**UT to Clarke Creek Stream and Wetland Restoration Site  
Annual Final Monitoring Report  
FINAL**

DMS # 92500

Monitoring Report Year 5 of 5  
Mecklenburg County, North Carolina

**Re: Comment Response Letter  
UT Clarke Creek Stream and Wetland Restoration  
DRAFT Monitoring Year 5 Report  
Yadkin River Basin – CU# 03040105  
Mecklenburg County  
DMS Project # 92500; DENR Contract No. 005363**

Reach	UT to Clarke Creek
River Basin	Yadkin/Pee Dee
Cross Section ID	XSC-9, Riffle, 2+02
Drainage Area (Sq Mi)	1.08
Date	10/30/2018
Observers	D. Moose, B. Wahab

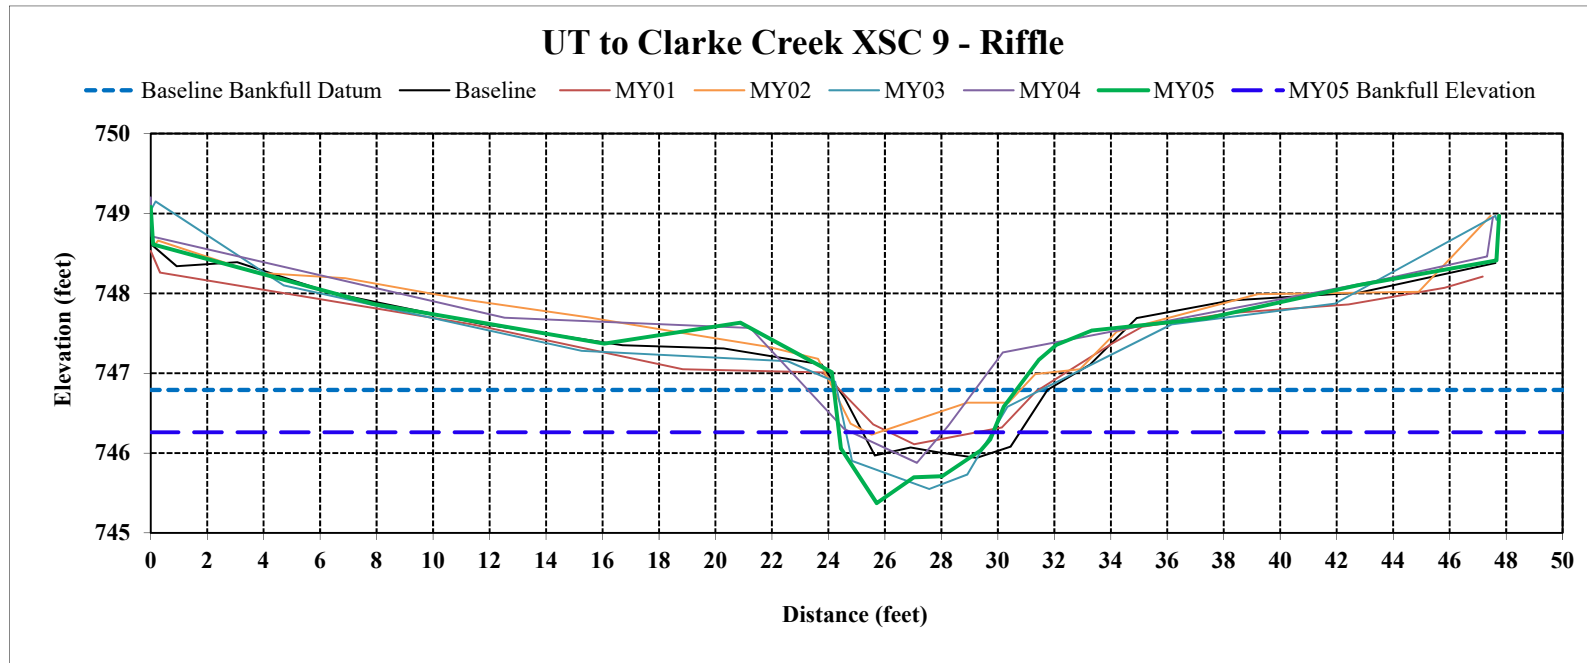
*The large change of BHR on XS1A and XS 9 appears visually inconsistent with changes seen in the graph. This may be an artifact of the new calculation method but appears questionable. Please verify the calculations (guidance attached).*

Cross Section 9						
Monitoring Year	0 (baseline)	1 (2014)	2 (2015)	3 (2016)	4 (2017)	5 (2018)
Bankfull area (ft <sup>2</sup> )	2.8	2.48	3.47	4.41	3.1	2.8
Bankfull Elevation (ft)	746.79	746.79	746.79	746.79	746.79	746.3
Thalweg Elevation (ft)	745.94	746.11	746.23	745.55	745.88	745.37
Bankfull d max (ft)	0.85	0.68	0.56	1.24	0.91	0.9
Low Bank Elevation (ft)	747.11	747.01	747.18	746.89	747.57	747.53
Low Bank Height (ft)	1.17	0.9	0.95	1.34	1.69	2.2
BHR	1.4	1.3	1.7	1.1	1.9	2.4

The change in BHR on Cross Section 9 is mainly a result in the change of the thalweg elevation. The bankfull cross sectional area remained roughly the same (2.8 – 4.4 ft<sup>2</sup>) even though the bankfull elevation decreased by approximately 0.5 feet. Between MY04 and MY05, the maximum bankfull depth did not change (0.91 and 0.93 feet respectively). The bankfull cross sectional area and maximum depth showed little change because the thalweg elevation decreased roughly the same amount as the bankfull elevation (0.5 feet). This decrease in thalweg elevation and roughly consistent low bank elevation increased the low bank height subsequently increasing the BHR.

### Supplemental Stream Gauge Data

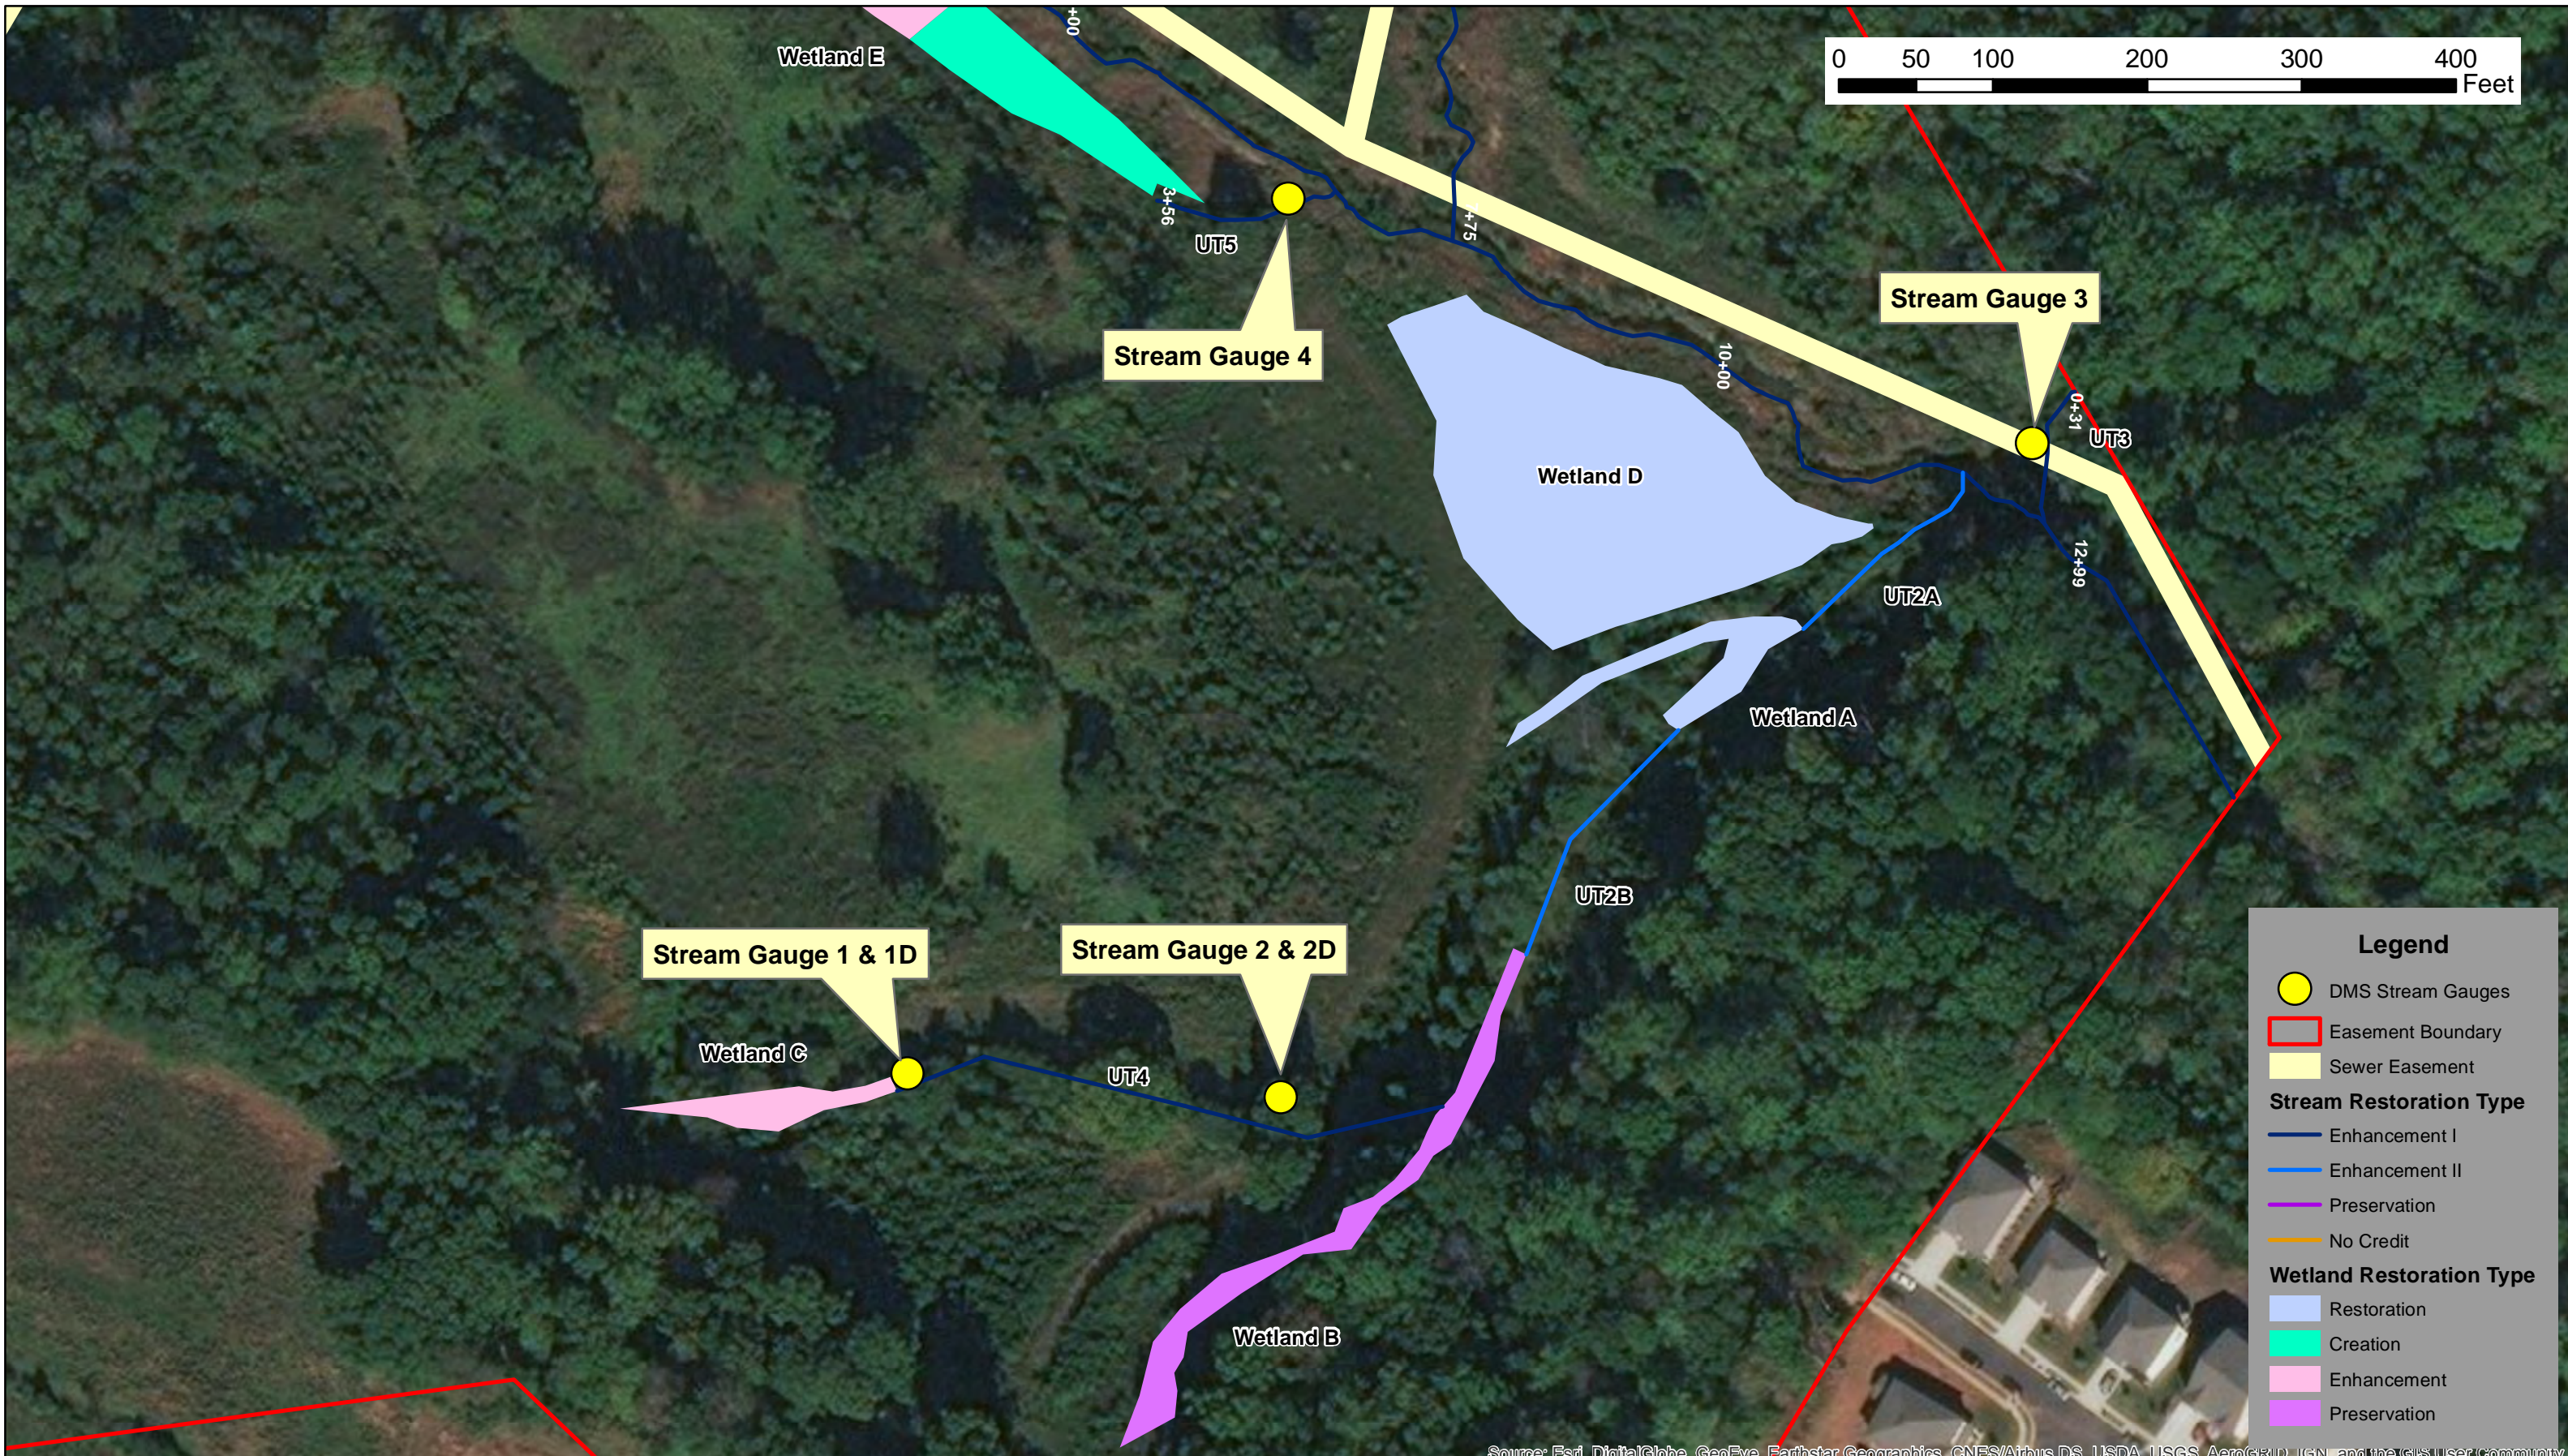
**Comment:** *General: DMS had concerns regarding the persistence of flow hydrology in UT3, UT4 and UT5 in MY4. DMS installed and monitored flow gauges in these reaches during MY5. A stream gauge location map and the associated stream flow graphs are attached. Please include this attachment as an Appendix and reference it in the report text in the final MY5 report.*

**Response:** The following text was added to the report: "Monitoring gauges were installed by NCDMS on UT3, UT4 and UT5 to document surface flow within the tributaries during MY05. One gauge was installed on UT3; four on UT4 and one on UT5. All gauges showed surface flow for greater than 120 consecutive days between January 2018 and October 2018."

The map and graphs were added in Appendix F: Supplemental Stream Gauge Data.
